GOODMAN
PARKING RATE
DISCUSSION
85-97 WATERLOO RD
SSD-52604208

**RE: 85-97 Waterloo Rd & 2 Banfield Rd, Macquarie Park – Build to Rent SSD-52604208)
Response to City of Ryde Submission – Section 12 Sustainability and Resilience, Section 14
Traffic generation and Infrastructure improvements**

**RE: 85-97 Waterloo Rd & 2 Banfield Rd, Macquarie Park – Build to Rent SSD-52604208
 Response to City of Ryde Submission – Section 10(a) Parking Provision**

**RE: 85-97 Waterloo Rd & 2 Banfield Rd, Macquarie Park – Build to Rent (SSD-52604208)
 Response to City of Ryde Submission – Section 10(b) Vehicle access and service facilities
 and Section 14 Traffic generation and Infrastructure improvements.**

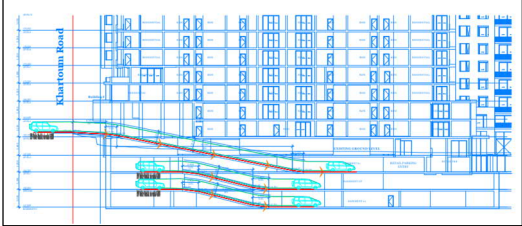
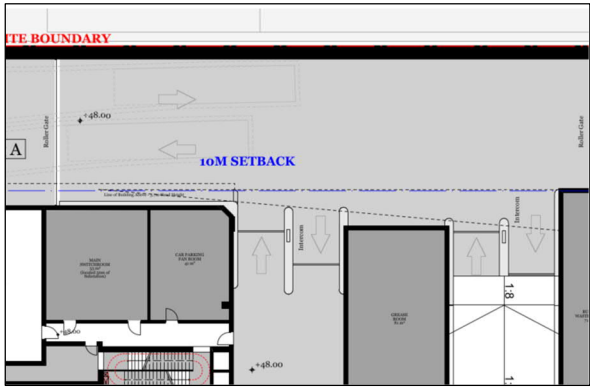
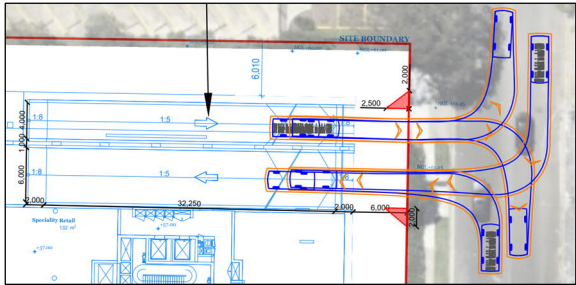
10. Vehicle Access, Parking and Service Facilities	
(b) –Vehicle access and service facilities - General	
Item	Response
1	<p>There is scope the parking layout could be reconfigured to provide a more efficient layout as it appears there are several points of conflicting vehicle flows along the access paths. It is advised that a swept path analysis be undertaken with the design to identify areas of improvement, noting that "hard" (ie 90 degree) corners are to provide either a curved inner radius or splay to accommodate the inside swept path.</p> <p>Noted. The architectural plans have been updated. The car parking areas have been reviewed against AS2890.1:2004, and all car parking areas have been updated to generally be in accordance with AS2890.1:2004. The User Class and parking spaces dimensions for different uses are outlined in below table, refer to Appendix A for details and additional design commentary.</p>

<p>vehicles approaching from the Banda Road entry and presents a traffic safety issue.</p> <p>management devices such as give-way signages and mirrors to be installed and provide the visibility for the oncoming vehicles.</p> <p>Moreover, the architectural plans have been updated to provide sight distance for Basement 02 access driveway, which is shown in below figure.</p> 
<p>5 The design presents entries to both basement levels (01 & 02) adjoining another. The arrangement presents a traffic safety issue associated with the conflicting movement of a vehicle entering basement 02 entry as a vehicle emerges from basement 01. Details on signage / landmarking are considered warranted.</p>	<p>Noted. The architectural plans have been updated to provide separation between Basement 01 and 02 driveways, refer to Appendix A for details.</p>
<p>6 The two visitor spaces located at the base of the ramp descending from Basement 01 to 02 are poorly placed and will require (at best) a reverse in manoeuvre to enter and 3-point turn to exit. This will result in congestion in the parking area and is poor design.</p>	<p>Noted. The parking layout has been updated, refer to Appendix A for details.</p>

<p>(b) –Vehicle access and service facilities - Eastern Basement Parking Levels</p>	
<p>7 The parking area accommodates 377 parking spaces and would be (generously) considered a Class 1, 1A parking facility (residents only). AS 2890.1 advises that the driveways to such areas should provide a separate entry and exit, with the entry width being 6m wide and the exit being 4-6m wide. The proposed 6m combined entry and exit is therefore well short of this.</p>	<p>Noted. The access at Khartoum Road design has been updated as per AS2890.1:2004 requirements, refer to Appendix A for details.</p>

8	<p>The design appears to present a one-way circuit arranged clockwise (based on the wheel stop positions associated with the parallel spaces) however this will require entering vehicles to perform a relatively tight "U-Turn" at the base of the entry ramp due to the ramp facing west, opposite to this flow. The arrangement is such that less abled drivers may potentially be unable to do this in one manoeuvre, requiring them to do a multipoint turn, resulting in considerable congestion at this point. This could also present a high potential for property damage to vehicles and also creates a traffic safety issue in the event of conflicting flow (say a vehicle entering the basement as another vehicle approaches the exit as the entering vehicle is required to manoeuvre into the ascending (opposing) lane prior to the turn.</p>	<p>Noted. The parking layout has been updated, refer to Appendix A for details.</p>

<p>It is expected that full compliance to AS series will form part of a Condition of Consent (CoC) which can readily be addressed during Construction Certificate (CC) stage of the project.</p>	LAYOUTS OF PARKING SPACES				USES	USER CLASS	SPACE DIMENSION	AISLE WIDTH	RESIDENTIAL	CLASS 1A	5.4m x 2.4m	5.8m	VISITOR	CLASS 2	5.4m x 2.5m	5.8m	RETAIL	CLASS 3A	5.4m x 2.6m	6.6m	RETAIL	CLASS 3A	5.4m x 2.7m	6.2m
LAYOUTS OF PARKING SPACES																										
USES	USER CLASS	SPACE DIMENSION	AISLE WIDTH																							
RESIDENTIAL	CLASS 1A	5.4m x 2.4m	5.8m																							
VISITOR	CLASS 2	5.4m x 2.5m	5.8m																							
RETAIL	CLASS 3A	5.4m x 2.6m	6.6m																							
RETAIL	CLASS 3A	5.4m x 2.7m	6.2m																							
<p>2</p>	<p>Detailed ramp profiles are required as the plans are too conceptual to gauge whether ramp grades and height clearances are satisfactory. To ensure compliance with AS 2890, driveway ramp profiles must be prepared and be taken along the vehicle path of travel and along the inside swept paths on curves (this presents the worst case due to the path having the shortest ramp level and greatest level differences). The profile shall clearly indicate grade lengths, grades (presented as %'s) and levels which correlate with the proposed development levels and surveyed boundary levels. Any overhead structures and / or parking levels under the ramp must be noted to ensure that adequate vehicle clearances are provided both on the ramp (and under the ramp if proposed). All grades and height clearances must be in accordance with the relevant section of AS 2890 for the access design vehicle.</p>	<p>Noted. Vehicular clearance of ramps has been assessed and provided in Appendix A. The ramp grades and height clearances are satisfactory on the current plans.</p> <ul style="list-style-type: none"> - Building A, B & C  <ul style="list-style-type: none"> - Building E, F & G 																								
<p>3</p>	<p>End-of-trip facilities are warranted for the staff/retail component. The Traffic Report presents these could be addressed in the CC stage however it is considered this detail should be present in the development consent plans.</p>	<p>Noted. The architectural plans have been updated to allocate a total of 93 m² GFA as End-of-trip facilities (EoTF), 58 m² GFA and 35 m² GFA for each building respectively. It is expected that the further details of the EoTF will be included at detailed design stage and a Green Travel Plan will be provided in response to a suitable CoC.</p>																								
<p>(b) –Vehicle access and service facilities - Western Basement Parking Levels</p>																										
<p>4</p>	<p>The crest of the ramp from Basement 02 and Basement 01 access has no sight distance to</p>	<p>Noted.</p> <p>There is not a ramp connected to Basement 01 access driveway, hence it is expected that traffic</p>

DOCUMENT INFORMATION	
DESIGN REVIEW	
BUILDING E/F/G, LEVEL 02 PLAN - LV	
FILE NAME AG2235-01-v15 - 85-97 Waterloo Road.dwg	SHEET AG08

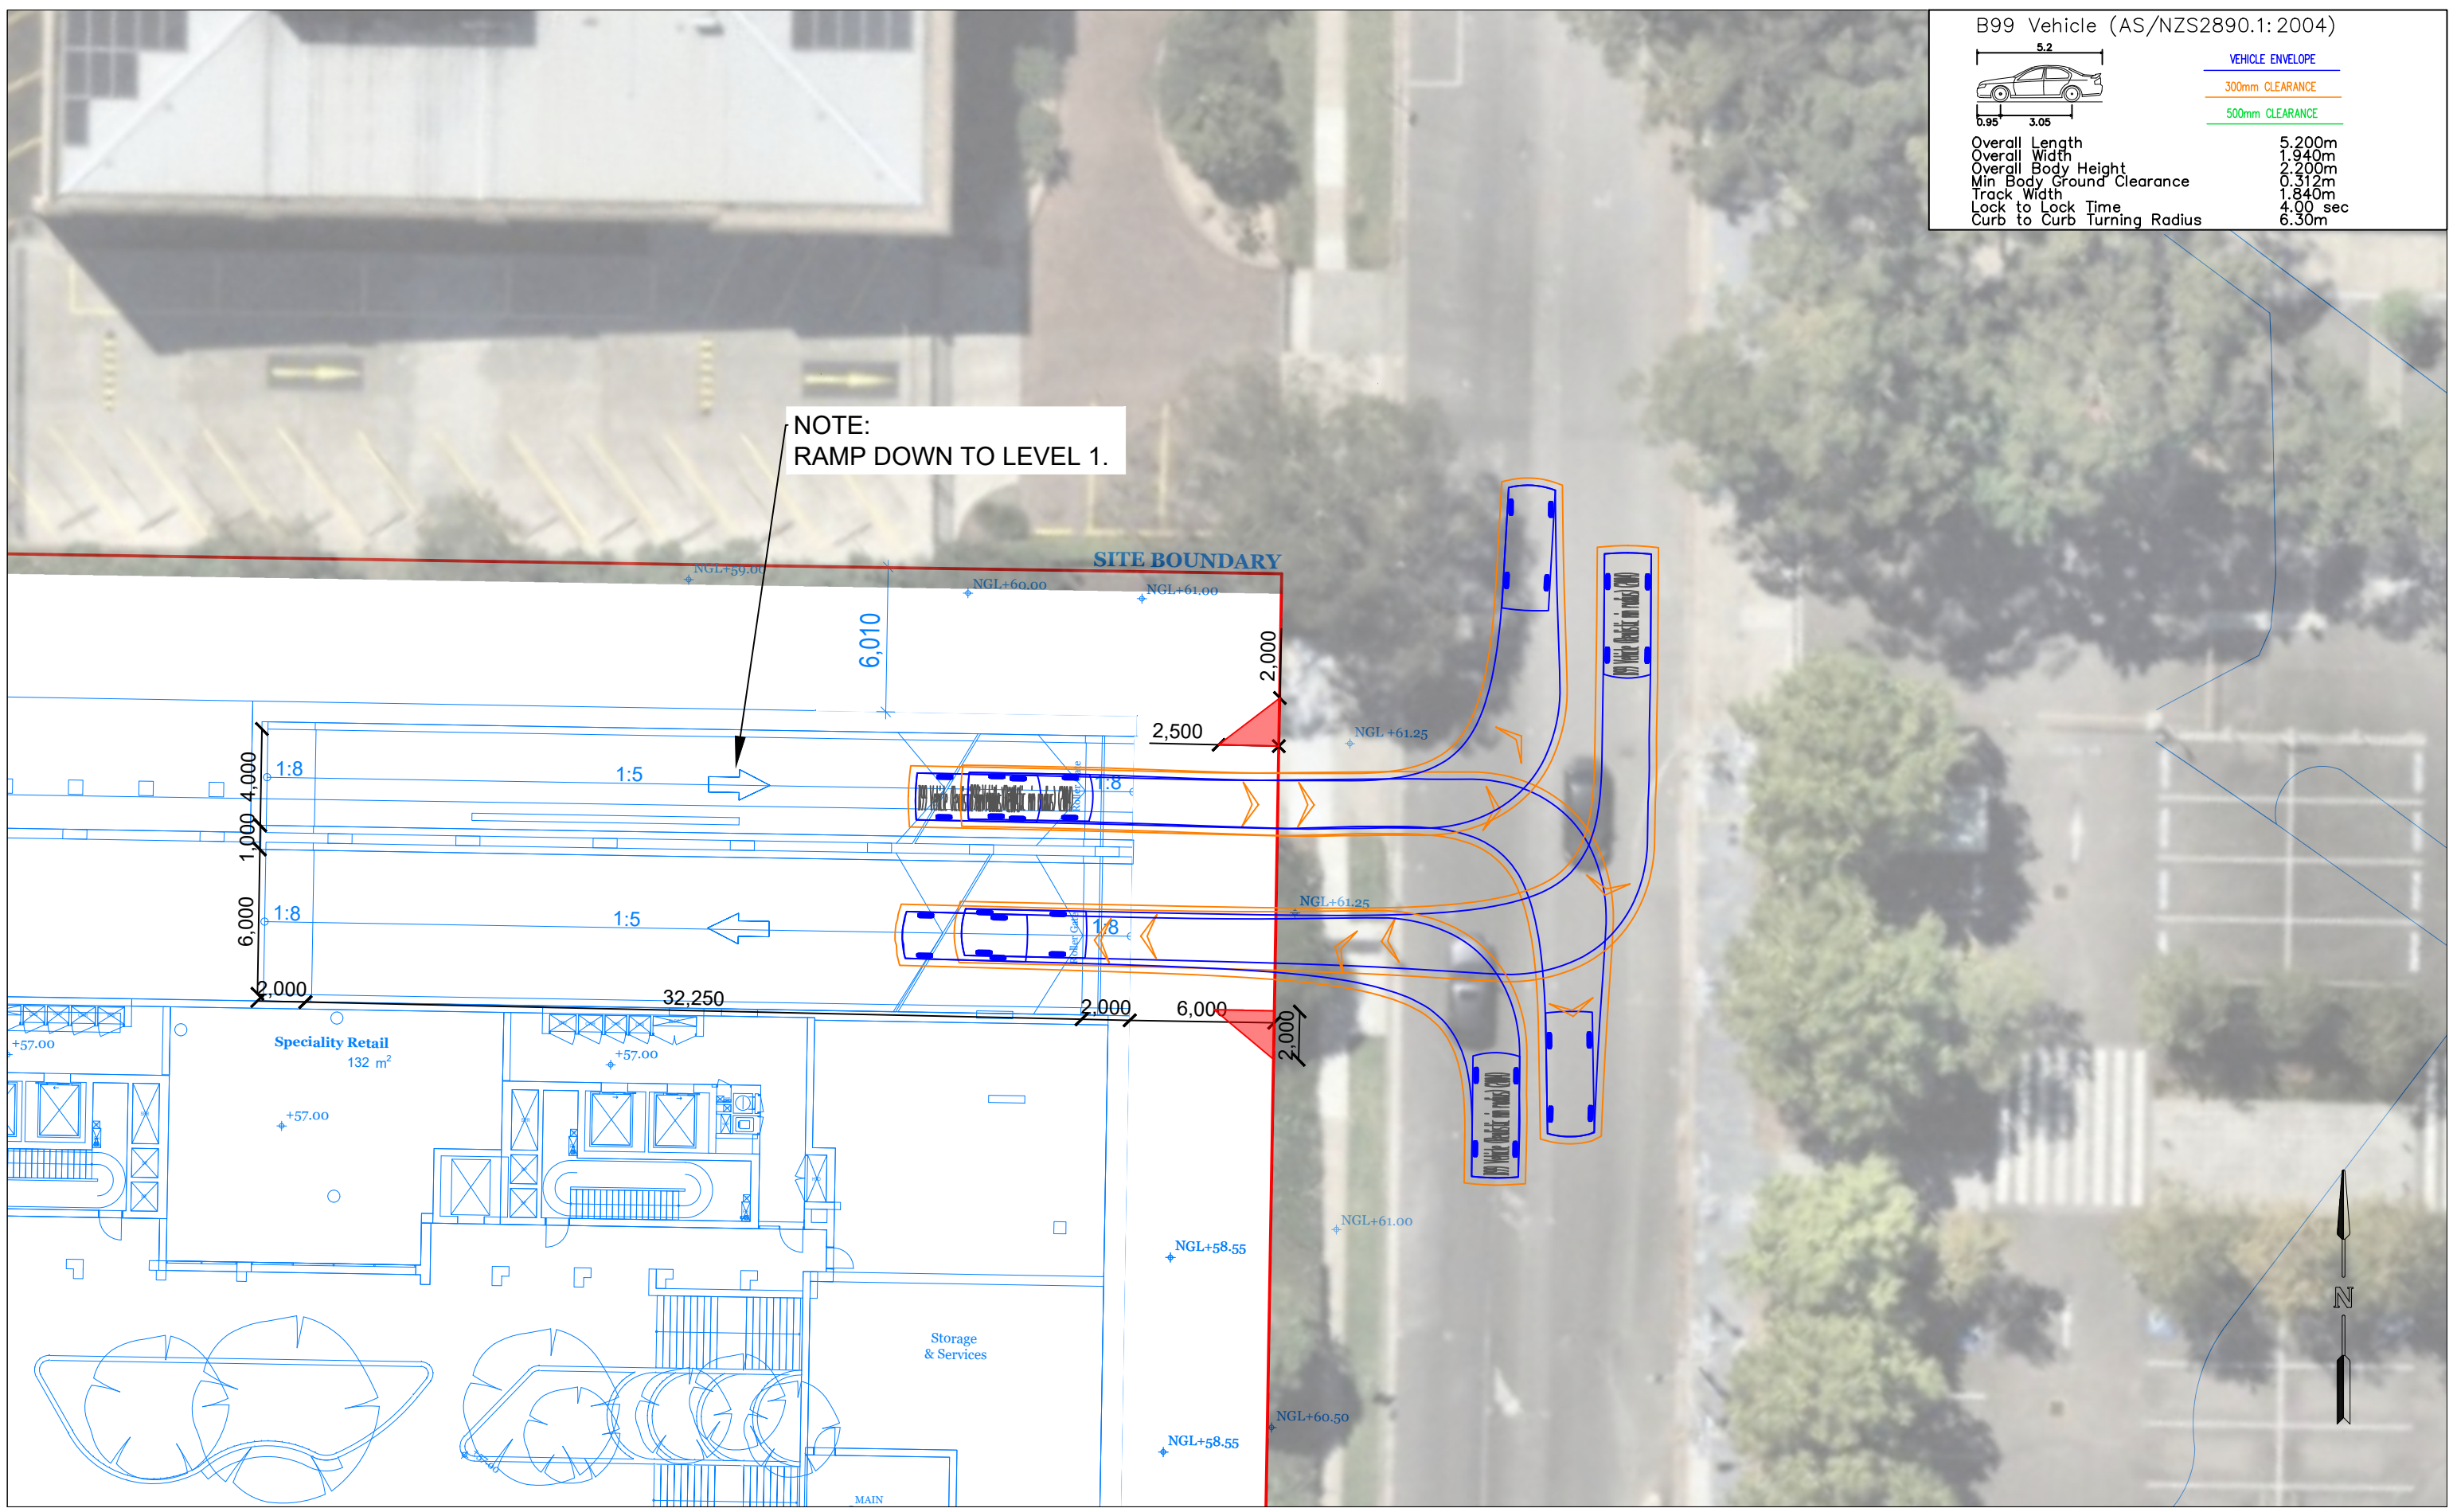
- 1.1. ACCESS POINT 1 AT BANDA ROAD WILL BE USED BY HEAVY VEHICLE (HV) AND LIGHT VEHICLE (LV) ENTRY AND EXIT.
- 1.2. ACCESS POINT 2 AT KHARTOUM ROAD IS SHOWN ON LEVEL 01 PLAN, AND SHALL BE LIMITED TO LV ENTRY AND EXIT, REFER TO AG08.
